TECHNICAL DECISION RRJ0000-OR-470-1975

on continued airworthiness of RRJ-95 type aircraft due to non-conformity in the mounts of passenger cabin windows retainers p/n T7.92.0704.105.000.70/B

Fig.1. Passenger Cabin Window.

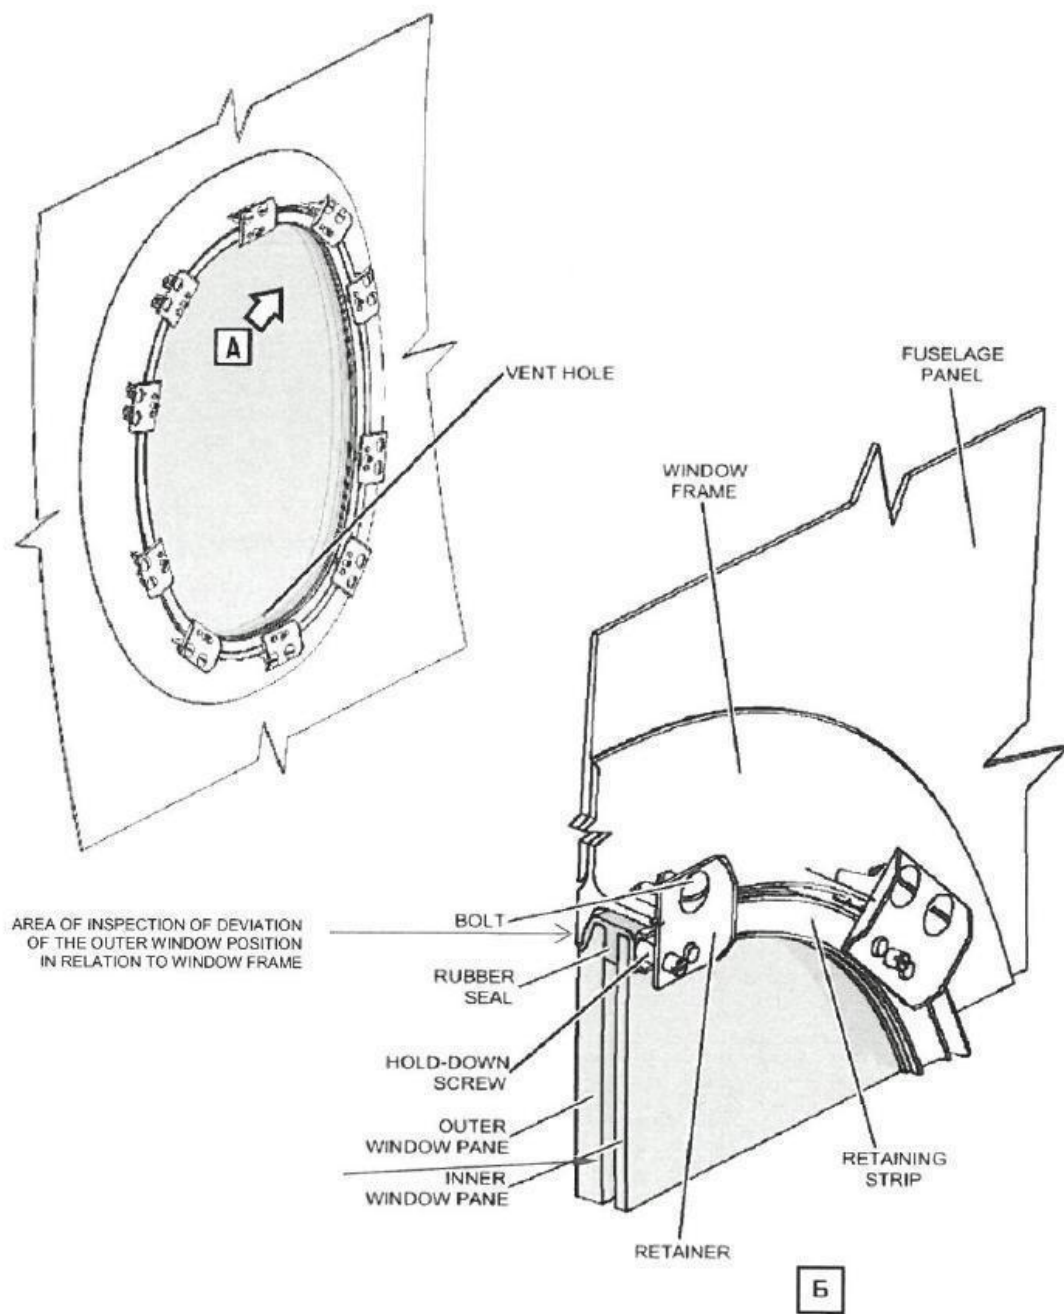
Due to identification of non-conformity in the mounts of passenger cabin windows retainers p/n T7.92.0704.105.000.70/B on AC RRJ-95B RA-89024 and RA-89026: loosen and fallen out hold-down screws 5-16-ХИМ.Пас.-ОСТ 1 31574-80, as well as loss of locking features of anchor nuts 5-Ц OCT 1 33264-89 the following decision has been taken:

NOTE 3: Installation of retainers p/n T7.92.0704.105.000.70/B with the bolts p/n 5-12-Ц-ОСТ 1 31158-80 to be performed with application of a thin layer of paste LU-052 or sealer IS-069 on a threaded part of screws after preliminary cleaning of the contacting surface of the retainer and retaining strip (see Fig.1) with a cleaning rug soaked in solvent.

NOTE 2: During retainers installation instead of previously installed hold-down screws p/n 5-16-Хим.Пас-ОСТ 1 31574-80 to perform installation of new screws with hexagon head p/n 5-16-Хим.Пас-ОСТ 1 31503-80.

To perform tightening of screws IAW AMM 56-21-01-900-801. To perform tightening of screws 6 (clause 4 "Б (6)", page 402) as per the following procedure: removing one-by-one each screw on the opposite sides of the strip until the gap appearance, again tighten the screws until they contact with the retaining strip. After contact to turn the screw for 1.5 of the turn, at that deformation (bending) of the corner for 1.5 mm is allowed.
